**Housing Development at Cosmona,
Loughrea,
Co. Galway**

**Traffic and Transportation
Assessment**

- 1.1 This report describes a Stage 1/2 Road Safety Audit carried out at a proposed housing development at Cosmona in Loughrea, Co. Galway. The site is a greenfield site adjacent to the R350 Loughrea to Bullaun Road. The land use is currently agricultural grass land. At the northern end of the proposed development, Cosmona will be connected to the Hazelwood estate via access roads and pedestrian/cycleways. The audit was carried out on 13th of September 2024 in the offices of Roadplan Consulting, Kilkenny.

Location: Hazelwood Estate

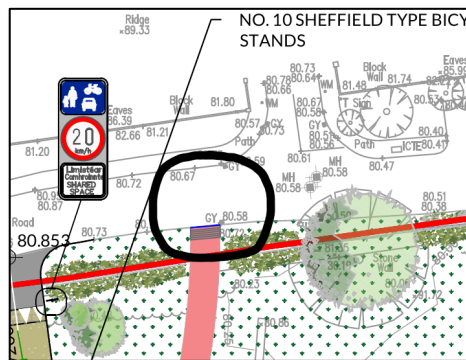
The design drawings show that the shared footpath/cycletrack ends suddenly at the main access road of the adjacent Hazelwood estate. Cyclists and pedestrians at the end of the track may have limited visibility to the east due to overgrown vegetation. Drivers in the Hazelwood estate may not anticipate cyclists and pedestrians emerging onto the roadway. It is also noted that no dropped kerb and tactile paving is provided opposite the crossing to enable pedestrians cross over to the opposing footpath. This situation could increase the risk of collisions involving pedestrians and cyclists.

Ensure sight lines comply with design standards and that motorists are warned of the presence of pedestrians and cyclists. Provide appropriate dropped kerbs and tactile paving in the footpath opposite.

- **Response:** The recommendation is accepted by the Design Team with adequate sight lines provided and also appropriate drop kerbs and tactile paving, see drawing 11942-2004 & 2005 for details.

Location: Entrance Avenue

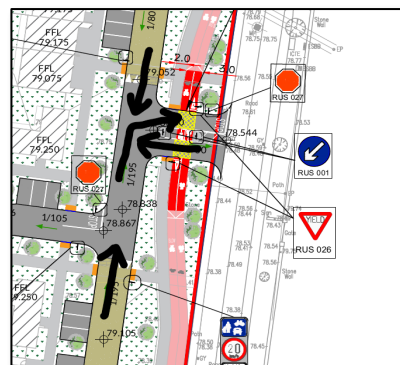
The design drawings indicate a relatively long and straight access road adjacent to the entrance. It is unclear who has right of way at this junction. A lack of clarity may lead to side swipe vehicle collisions at this location.

- **Response:** The recommendation is accepted by the Design Team with adequate guidance provided to motorists relating to right of way, see drawing 11942-2004 for details.

2.5 Problem: Termination for Cyclists from Cycle Track**Location:** Northern & Southern end of the Site

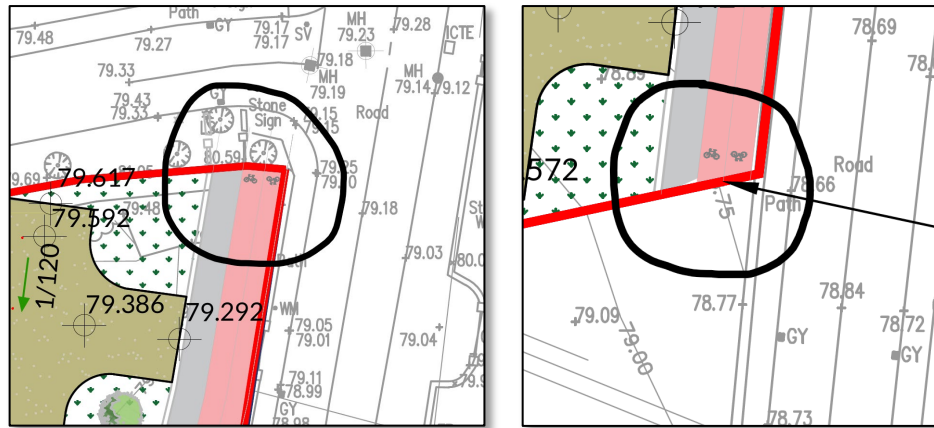
The drawings show a designated cyclist path, but it finishes suddenly at both ends without any details regarding its termination. The absence of features to help cyclists integrate with existing traffic and pedestrian facilities may heighten the risk of collisions involving cyclists

Ensure adequate features are designed and constructed to guide cyclists on and off the cycle track.

- **Response:** The recommendation is accepted by the Design Team with adequate provisions made to guide cyclists on and off the cycle track, see drawing 11942-2004 for details.

2.6 Problem: Termination for pedestrians from footpath**Location:** Northern & Southern end of the Site

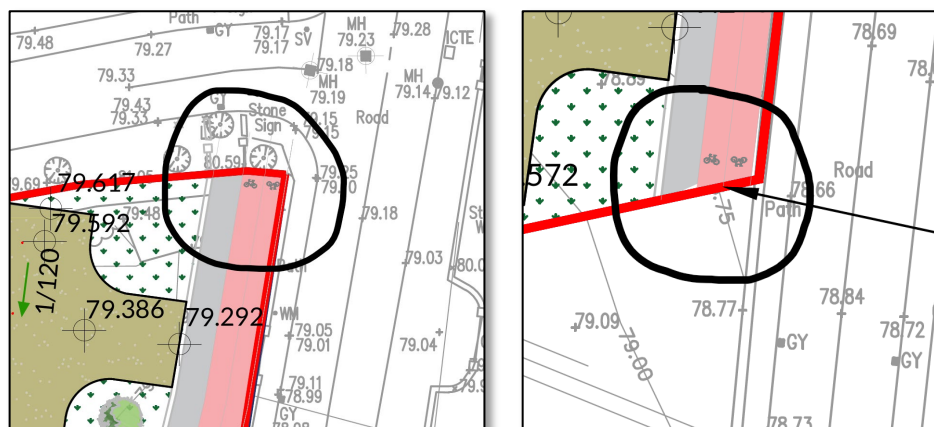
The drawings show a new footpath within the proposed development, but it finishes suddenly at both ends without any details regarding its tie-in to the existing footpaths. The absence of connections to the existing footpaths may increase the risk of collisions involving pedestrians.

Provide appropriate footpath connections to the existing footpaths.

- **Response:** Alternative measures are proposed by the Design Team with the extension of the footpath to the north to create an uncontrolled crossing, and a Lidl development of the lands to the south will provide pedestrian connectivity. This measure was accepted by the auditors.

2.7 **Problem:** Visibility Splays

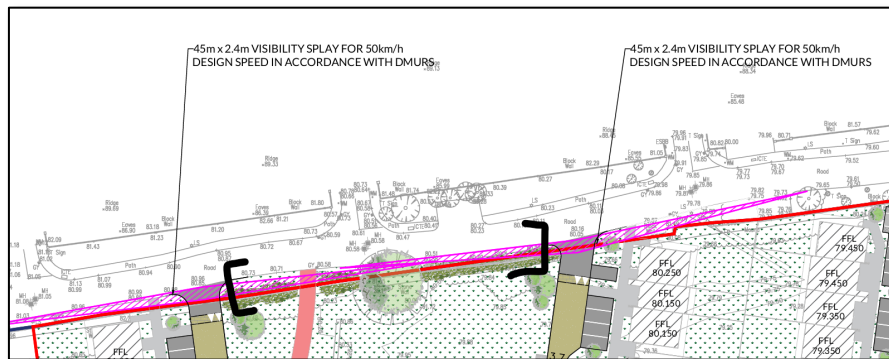
Visibility splays are indicated for both exits into the Hazelwood estate from the Cosmona Development. These visibility splays extend across existing vegetation and shrubbed areas. Over time, excessive growth coupled with a lack of ownership/maintenance may result in visibility splays being reduced. This may contribute to collisions when vehicles are exiting the junctions.

Ensure adequate visibility splays are provided and maintained. Remove trees & shrubbed areas within the extents of the visibility splays.

- **Response:** The recommendation is accepted by the Design Team with the provision of adequate visibility splays that are to be maintained, see drawing 11942-2004 for details.

2.8 **Problem:** Pedestrians Entering the Shared footpath/cycletrack

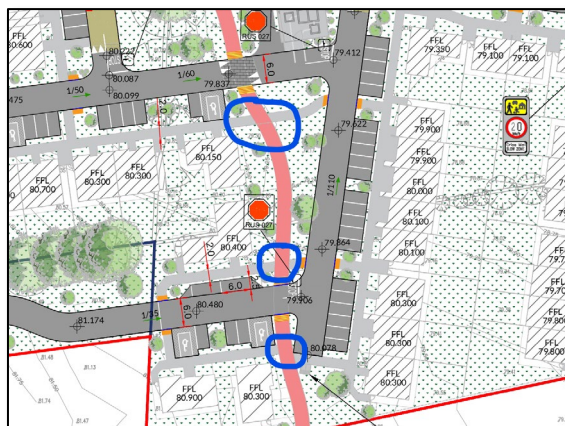
Pedestrians may not expect to encounter cyclists on the shared footpath/cycletrack and may not make room for cyclists to pass. This may be a particular issue for visually impaired persons, who may enter the shared surface unbeknown to them, resulting in collisions between cyclists and pedestrians.

Provide appropriate warning for pedestrians where the footpaths meet the shared footpath/cycletrack.

- **Response:** The recommendation is accepted by the Design Team with appropriate warning tactile provided where footpaths meet the shared footpath/cycletrack, see drawing 11942-2004 for details.

2.9 **Problem:** Inadequate Visibility
Location: Uncontrolled Pedestrian Crossings

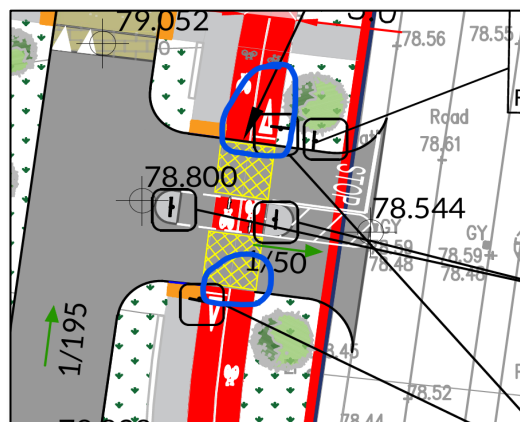
A number of uncontrolled pedestrian crossings are proposed throughout the development. However, it is unclear whether adequate inter-visibility is provided between drivers of vehicles approaching the crossings and pedestrians stopped waiting to cross. Obstructions to intervisibility may include planting, refuse bins and parked vehicles adjacent to pedestrian crossings.

Ensure adequate intervisibility between motorists & pedestrians is provided at uncontrolled crossings.

- **Response:** The recommendation is accepted by the Design Team with adequate intervisibility provided between motorists and pedestrians at uncontrolled crossings.

2.11 **Problem:** Cyclist Speed
Location: Main Entrance Crossing

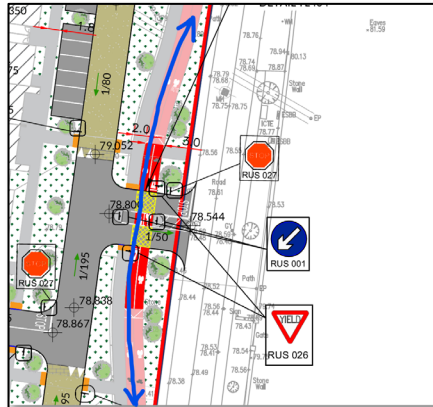
The design drawings indicate a gentle swept path for cyclists as they approach the crossing point. Cyclists approaching at speed may have difficulty stopping to give right of way to vehicles entering/exiting the development. This may result in side-swipe collisions between vehicles and cyclists.

Ensure the approach to the crossing for cyclists incorporates a suitable alignment that promotes cyclists to slow down in advance of the crossing, as outlined in TL404.

- **Response:** The recommendation is accepted by the Design Team with a suitable alignment of the approach provided that promotes cyclists to slow down, see drawing 11942-2004 for details.

2.12 **Problem:** Slow Zone Signage
Location: Throughout

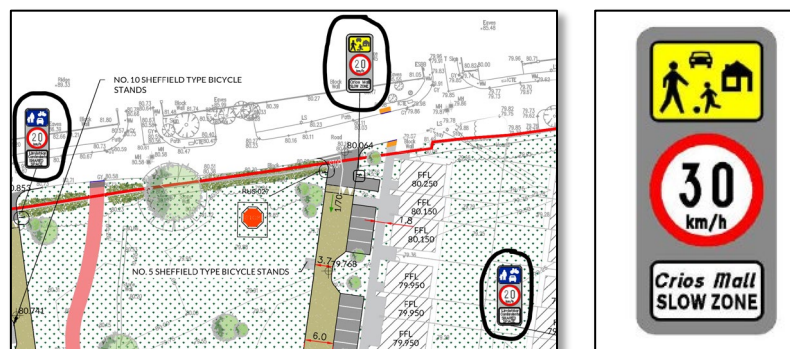
The design drawings indicate Slow Signage and other speed signage throughout. The Traffic Signs Manual indicates that Slow Zone signage for built up areas is 30km/h, however differing speeds are indicated on the design drawings. Confusion regarding the exact speed limit may cause drivers to ignore the actual speed limit, thus increasing the likelihood of accidents and collisions.

- **Response:** The recommendation is accepted by the Design Team with appropriate speed signage provided throughout the development, see drawing 11942-2004 for details.

2.13 Problem: Driver Confusion

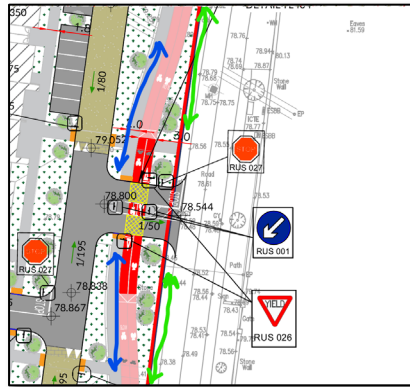
The design drawings indicate a new pedestrian footpath and crossing within the development. The drawings do not indicate what is proposed for the existing footpath that is between the boundary wall and the R350. Multiple crossing points in close proximity may cause confusion for motorists resulting in an increased likelihood of vehicle & pedestrian collisions.

Remove the existing footpath to limit pedestrians crossing at multiple locations.

- **Response:** The recommendation is accepted by the Design Team with the removal of the existing footpath to limit pedestrians crossing at multiple locations, see drawing 11942-2004 for details.

2.14 Problem: Pedestrian Delineation

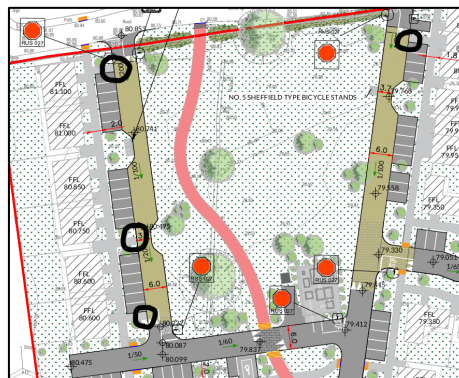
Footpaths and shared surfaces are planned within the development. However, it may not be clear to visually impaired pedestrians where the dedicated footpaths ends, and the shared surfaces begin. Consequently, they might inadvertently step onto the shared surface without realizing it, which could increase the risk of being struck by a passing vehicle.

Provide appropriate tactile warning at the interfaces of footpaths and shared surface.

- **Response:** The recommendation is accepted by the Design Team with the provision of appropriate warning tactile at the interfaces of footpaths and shared surfaces, see drawing 11942-2004 for details.

2.15 Problem: Disabled Parking**Location:** Throughout

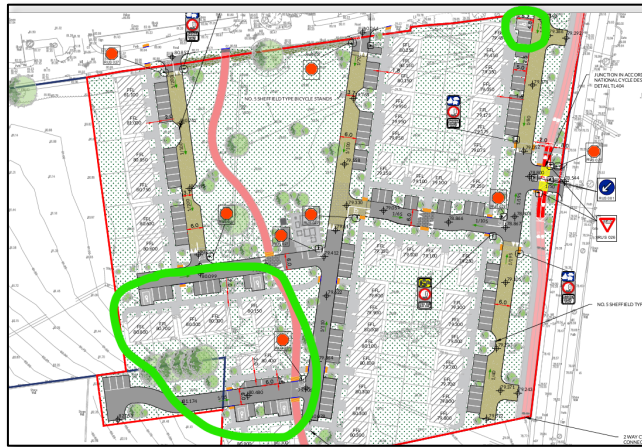
There are five disabled parking spaces, with four located in the southwest corner of the development. However, there are significant areas within the development that lack any disabled parking. Once parked, individuals with disabilities may need to navigate several road crossings to reach their destination, raising the risk of collisions between pedestrians and vehicles

Provide a more even distribution of disabled parking across the site.

- **Response:** The problem is not accepted by the Design Team as accessible parking has been located in close proximity to the single storey units where council tenants are most likely to require accessible parking, see drawing 11942-2004 for details.
